31/07-04 2805 Beechbank Road
Capitol View Park Historic District

TREE PRESERVATION PLAN FOR 2805 BEECHBANK RD

SUBJECT: Historic Area Work Permit #353422, New House Construction

Address: 2805 Beechbank Avenue (Capitol View Park Historic District)

SITE / ROOF PLAN

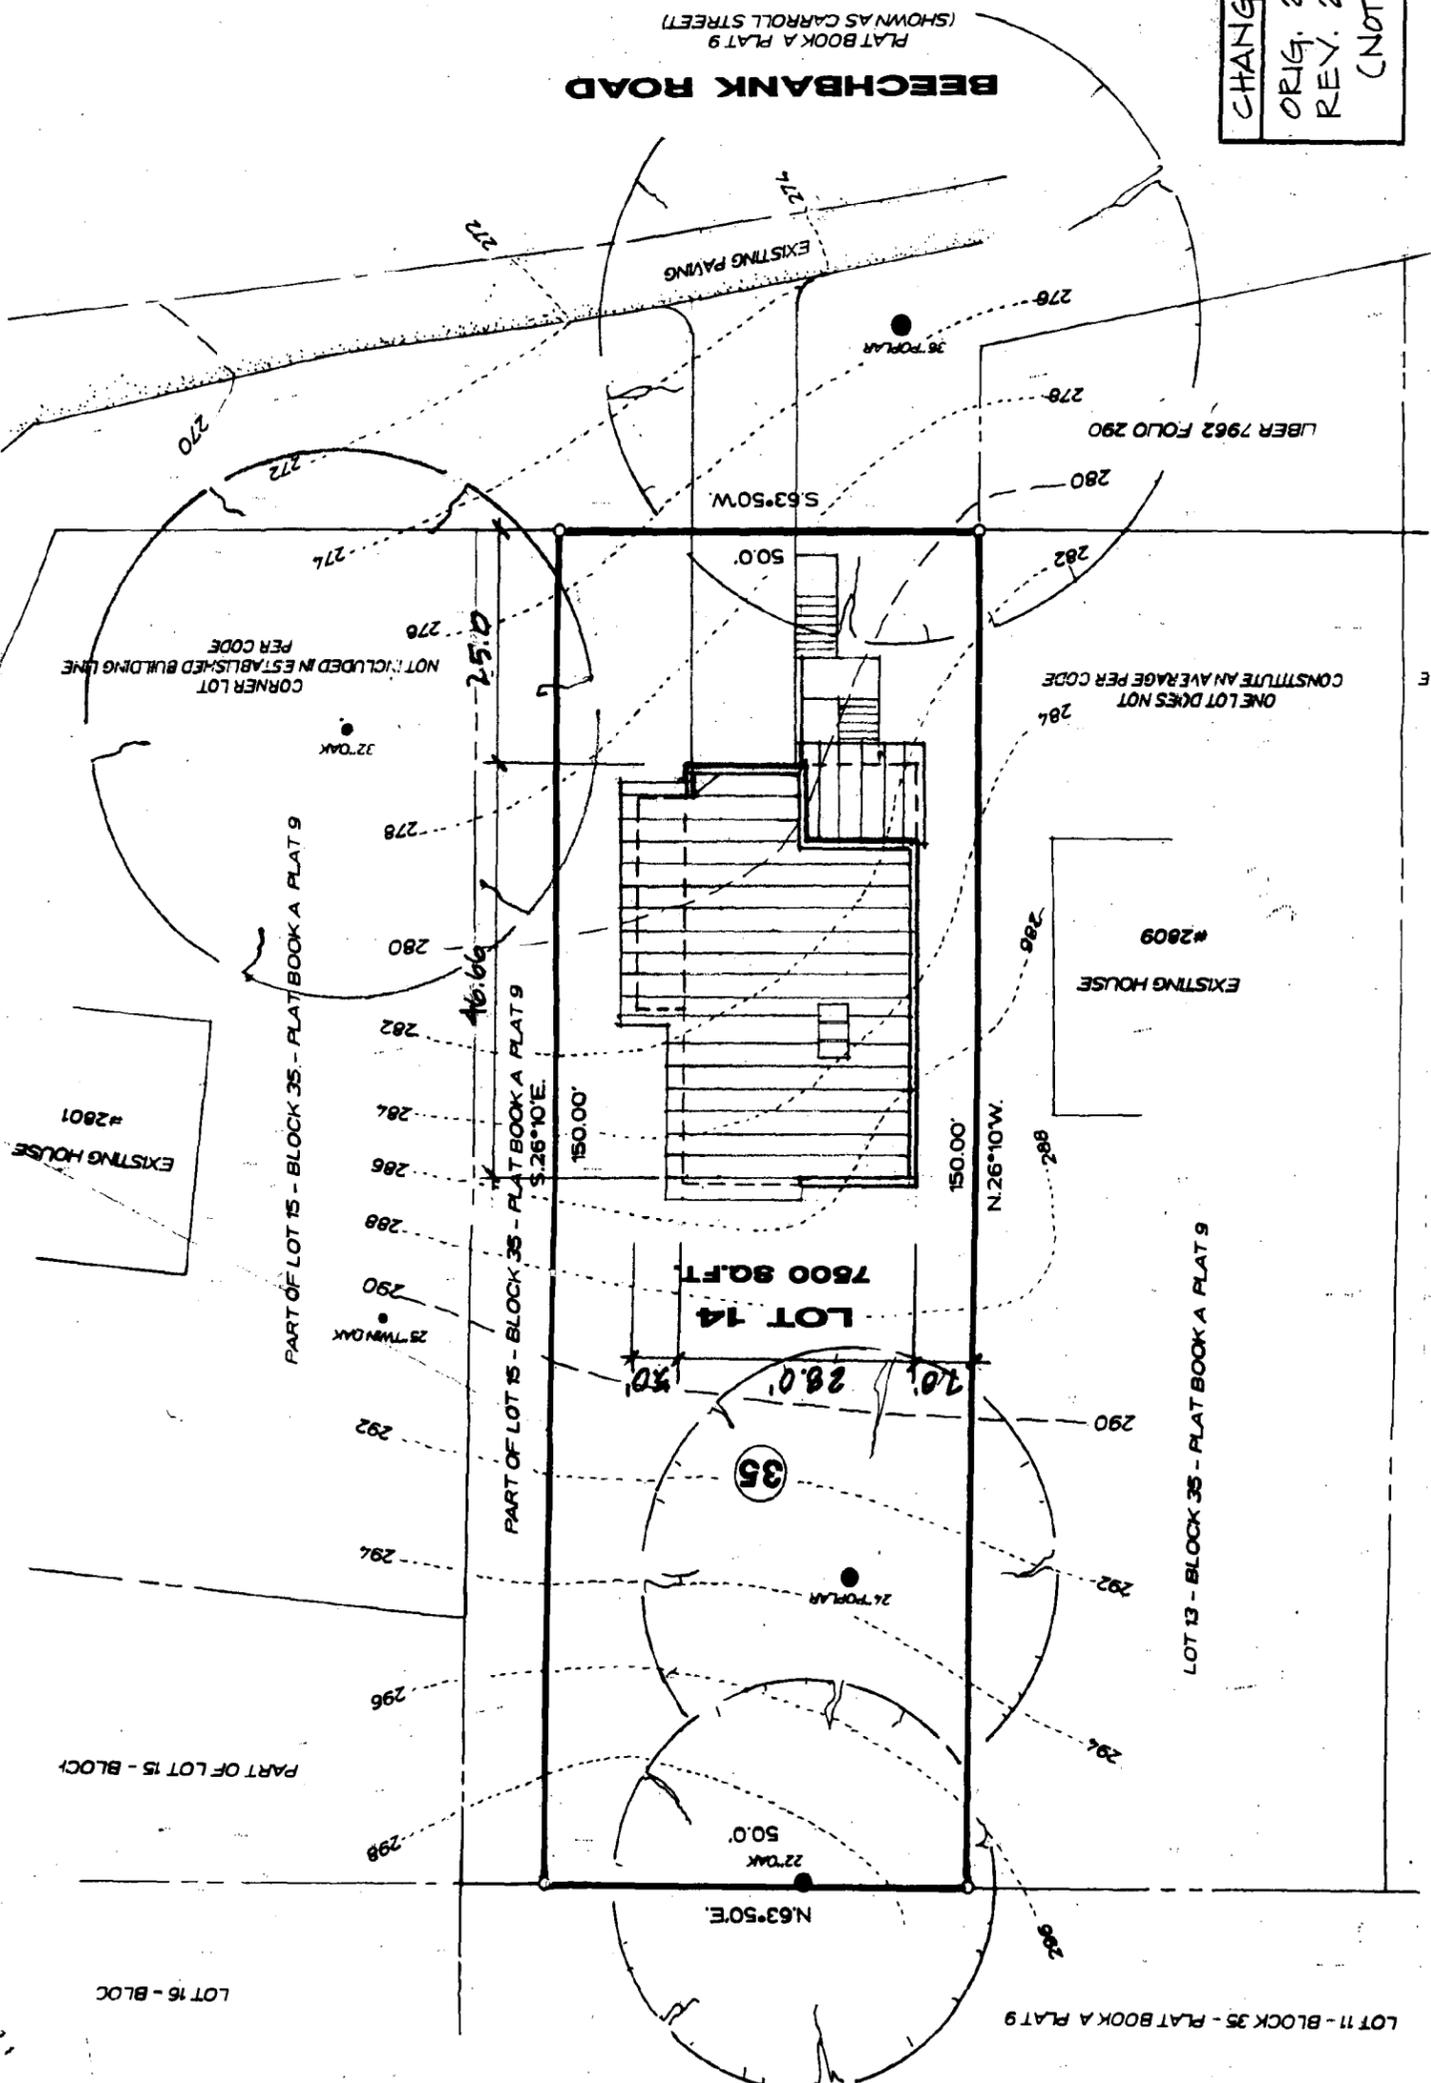
1. A reduction in the length of the new house's footprint.
2. A modification in the proposed material specifications to utilize painted, wood, vertical tongue and groove or cement fiber, board siding with wood battens.

15 The only concern that we had was in the proposed
16 footprint of the subject house. I will note, however, on
17 the site plan that you received in your packet, it's a
18 little misleading visually because as you'll note in the
19 drawings on the easel, there is a cantilevered section that
20 has been illustrated on the site plan that is actually not
21 part of the footprint, so the footprint will actually be
22 this dotted line that extends from the side elevation
23 straight down. So, there is a little bit more room there
24 visually, but the numbers in the staff report do reflect the
25 footprint as is. There is no modification on that, but I

1 think visually in terms of the goal of the Staff and the
2 direction that they gave the applicant is to try to set it
3 over as far to the west as possible, and I think that is
4 achieved if you eliminate that visually from the site plan.

CHANGES
ORIG. 29 JULY 04 FOOTPRINT: 1400 SF
REV. 21 SEPT 04 FOOTPRINT
(NOT INCL. 95 SF PORCH): 1190 SF
